ADDENDUM NO. 2

July 20, 2021

**THE CITY OF GREENVILLE, NC
NEW FIRE / RESCUE STATION NO. 7
4176 BAYSWATER ROAD, WINTERVILLE, NC 28590
ARCHITECTS PROJECT NO. 1658**

3 SECTION @ TOILET VANITY
 SCALE 1" = 1'-0" (FOR TOILET-101)

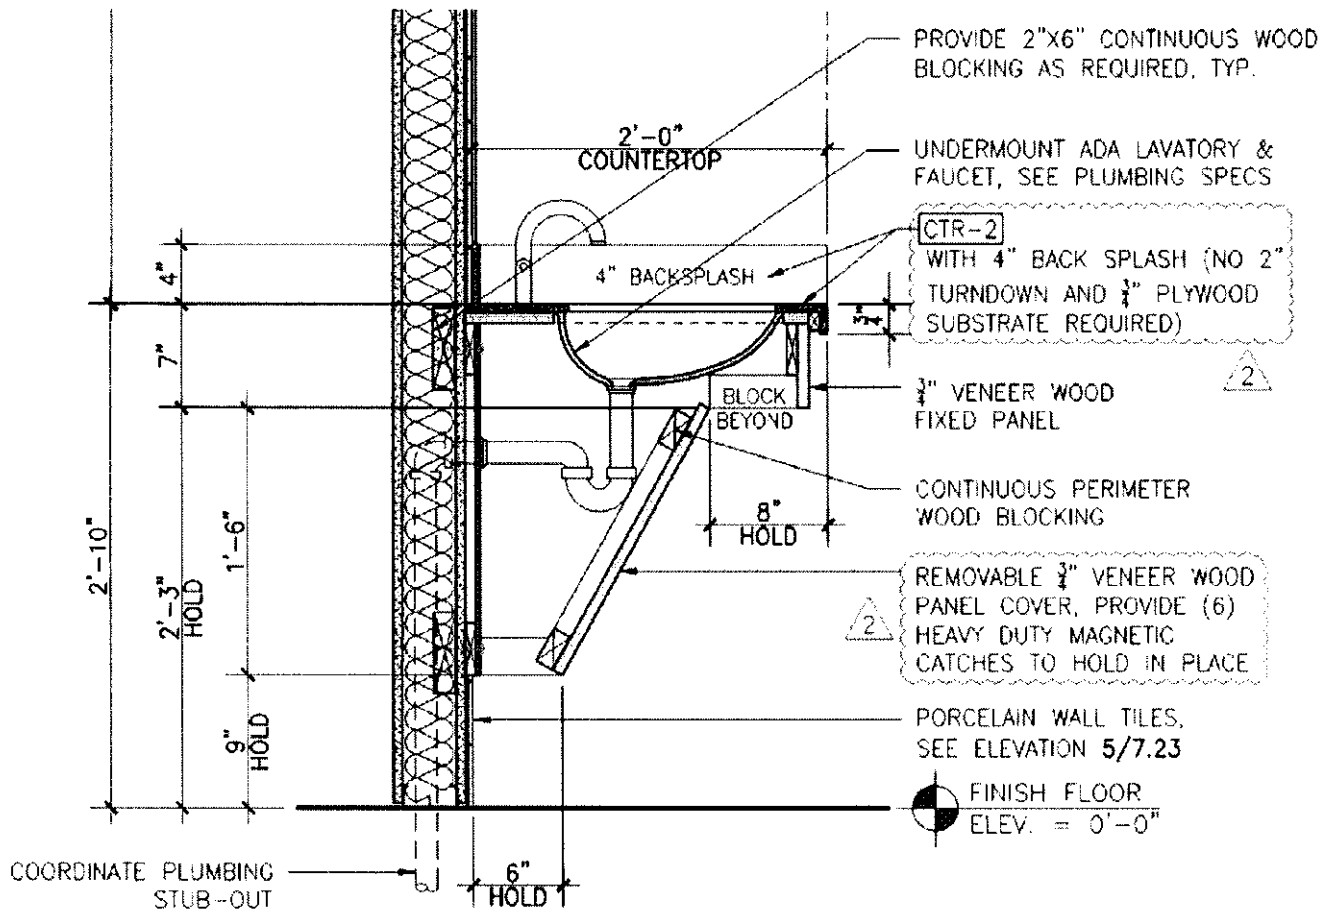
ABD-9 Casework modification drawing sheets 7.10 & 7.23.

<p>Stewart Cooper Newell Architects</p> <p>www.scn-architects.com 1.800.671.0621</p>	<p>719 East Second Avenue Gastonia, NC 28051 Phone 704.865.2311 Fax 704.865.0049</p>	<p>REFERENCE SHEET NO. 7.10 & 3/7.23 REVISED FINISH TAG DESCRIPTION FOR CTR-2 and CTR-3, SEE ABOVE RED CLOUDS.</p>	<p>DATE 07.20.2021</p>
<p>GREENVILLE FIRE / RESCUE #7</p>		<p>Architectural Bulletin Drawings ADDENDUM #2 ABD-9</p>

CTR-2 WILSONART QUARTZ COUNTERTOP (20mm THK.) - COLOR: KAREKARE Q3015, ²
 (FOR ALL TOILET VANITY TOPS). NO TURNDOWN & PLYWOOD SUBSTRATE REQUIRED.

CTR-3 WILSONART PREMIUM LAMINATE - WITH MACHINE APPLIED PVC EDGE BANDING (ALL CASEWORK DESKTOP) - COLOR: COSMIC STRANDZ 4941K-18 (LINEARITY FINISH).

ABD-10

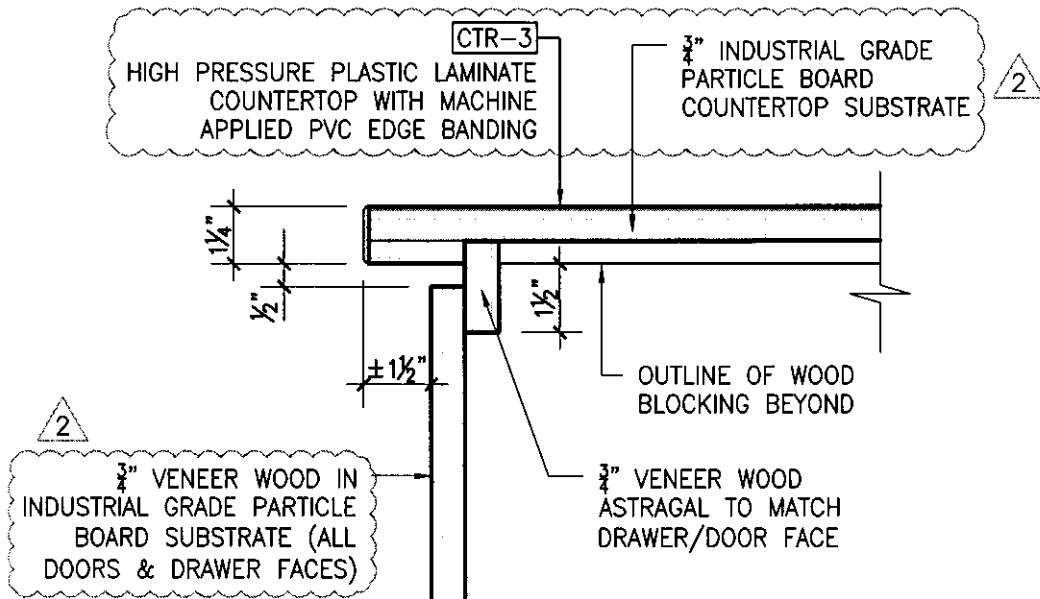
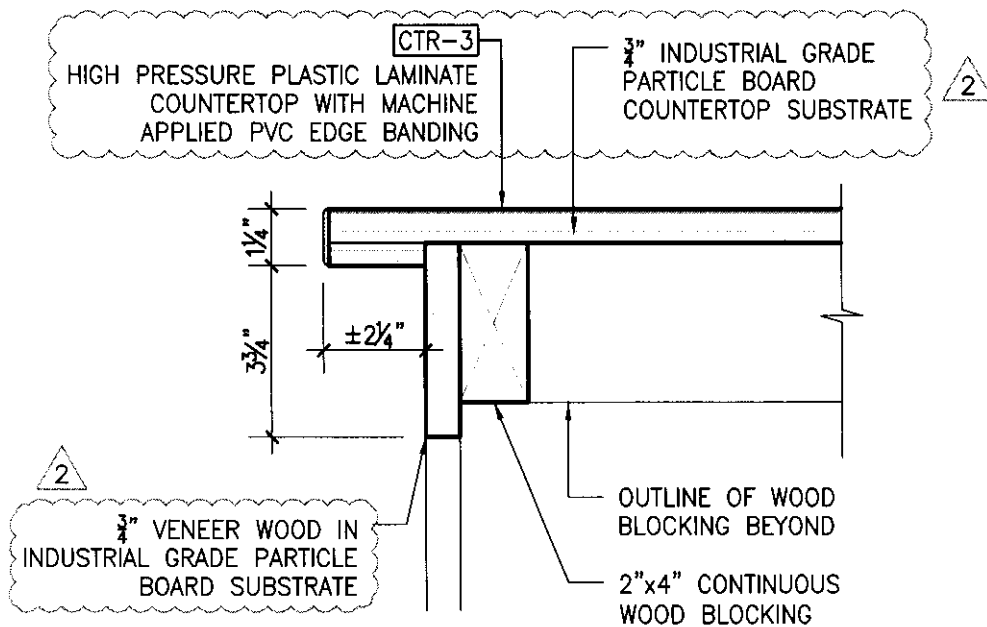
ABD-10 Casework modification drawing sheet 7.22.

REFERENCE SHEET NO. 10 & 11/7.22
DELETE BULLNOSE COUNTER EDGE &
REPLACE WITH MACHINE APPLIED
PVC EDGE BANDING.

2 KITCHEN ELEVATION
 SCALE: 1/4" = 1'-0"
 EXTRACTED FROM DRAWING #2, SHEET 7.20

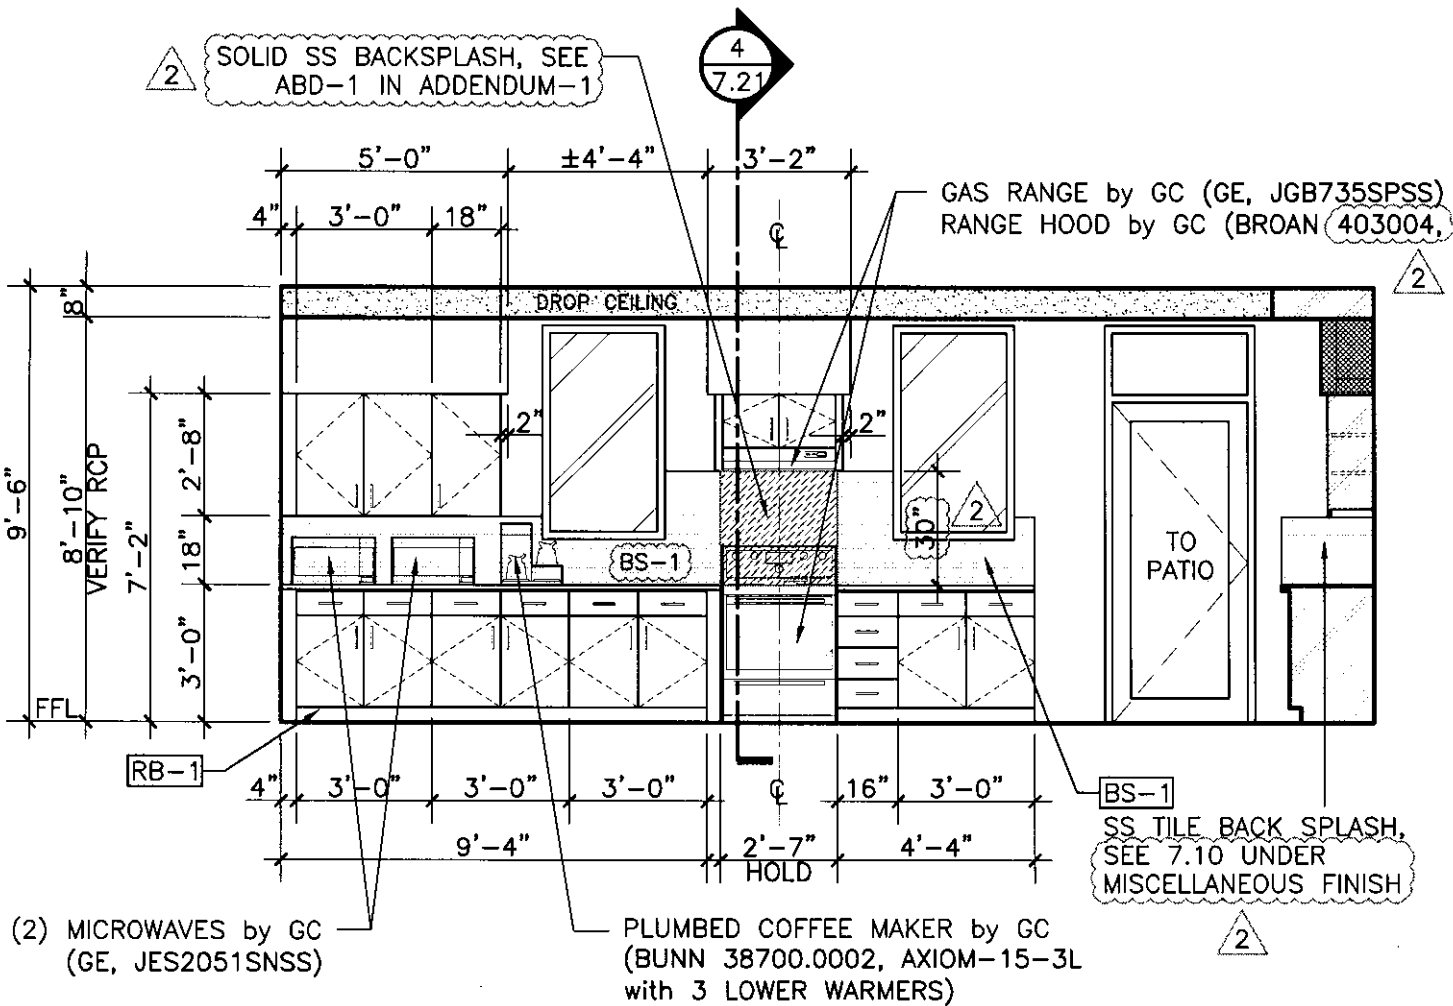
ABD-11 Kitchen elevation update drawing sheets 7.10 & 7.20.

<p>Stewart Cooper Newell Architects www.scn-artchitects.com 1.800.671.0621</p>	<p>719 East Second Avenue Greensboro NC 28354 Phone: 704.863.6311 Fax: 704.863.0946</p>	<p>REFERENCE SHEET NO. 2/7.20 & 7.10 SS SOLID BACKSPLASH BEHIND GAS RANGE REVISED RANGE HOOD SPECS. REVISED BS-1 SPECS.</p>	<p>DATE 07.20.2021</p>
<p>GREENVILLE FIRE / RESCUE #7</p>		<p>Architectural Bulletin Drawings ADDENDUM #2 ABD-11</p>

BS-1 KITCHEN BACK SPLASH, STAINLESS STEEL, METAL MOSAIC, SUBWAY WALL TILE 12"x12" (ITEM #: 354394, MODEL #: 20-617) LOWE'S.
~~CEMENTED CONCRETE WITH 2 COATS OF CONCRETE SEALER TOPCOAT~~

STAIR STRINGER CONNECTION @ 12" CMU WALL IN APP. BAY

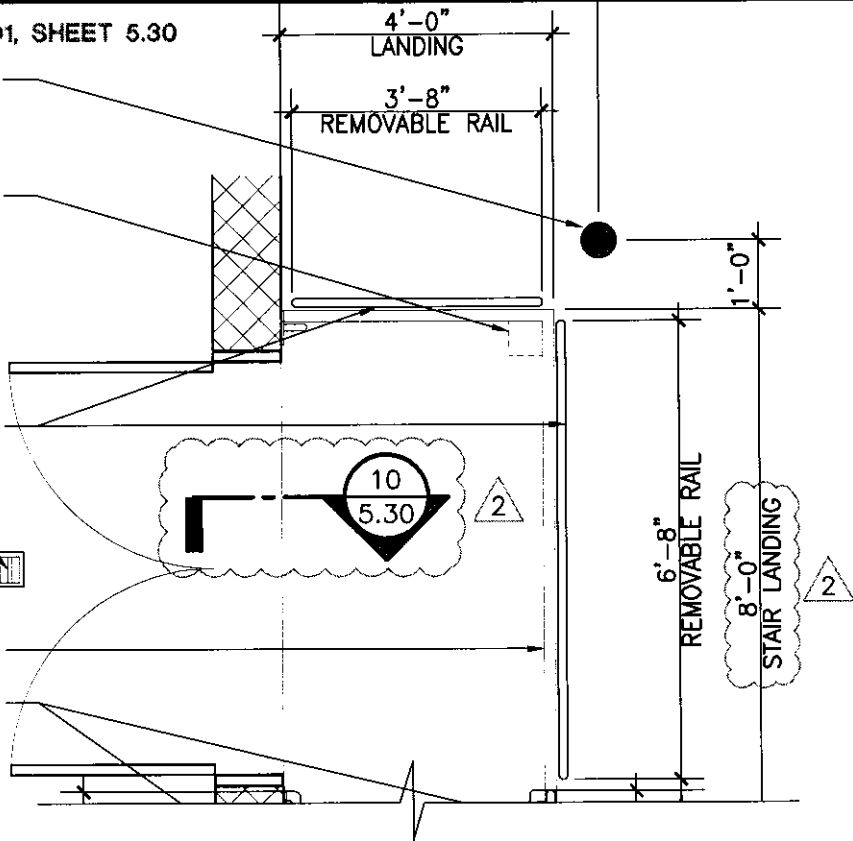
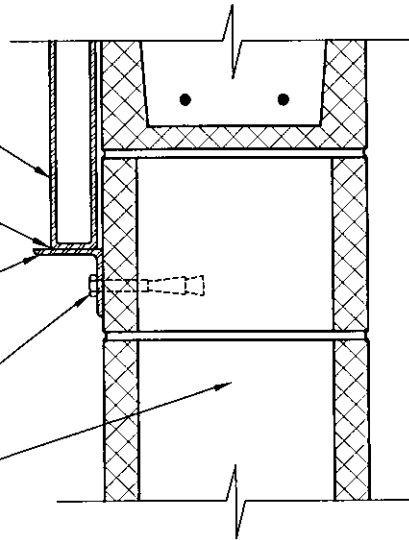
ABD-12 Stair stringer detail drawing sheet 5.30

THIS IS AN ADDITIONAL DETAIL IN SHEET 5.30

STAIR STRINGER CONNECTION
DETAIL TO 12" CMU WALL IN STAIR LANDING.
